CITY OF ALBUQUERQUE

RE: Lot 11 Block 9 Unit 5 SAD 227 6201 Casa Blanca NW Grading and Drainage Plan Engineers Stamp Date 9/26/19 (E10D065) Pad Certification Date 11/13/19

LOT11 BL9 U5 VOLCANO CLIFFS 6201 CASA BLANCA RD NW GRADING AND DRAINAGE PLAN

C1

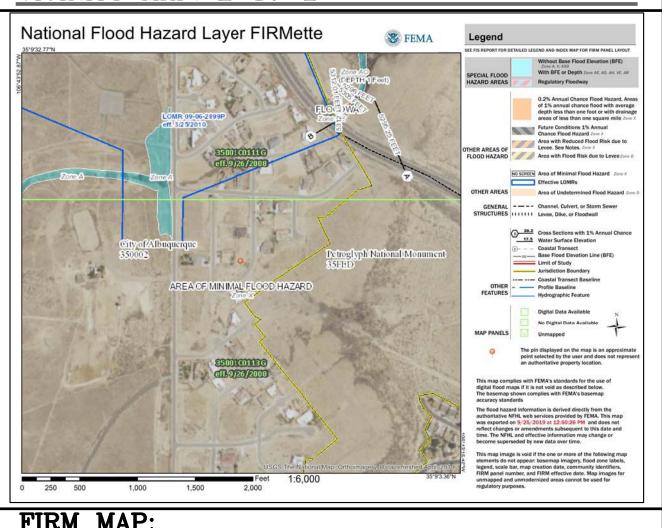
Based upon the information provided in your submittal received 11/14/19, this plan is approved for Building Permit.

Reiterate to the Owner/Contractor that a separate permit for a garden/retaining wall must be obtained, with the approved G&D plan dated 9/26/19.

Prior to Certificate of Occupancy release, Engineer Certification per the DPM checklist of this plan will be required.
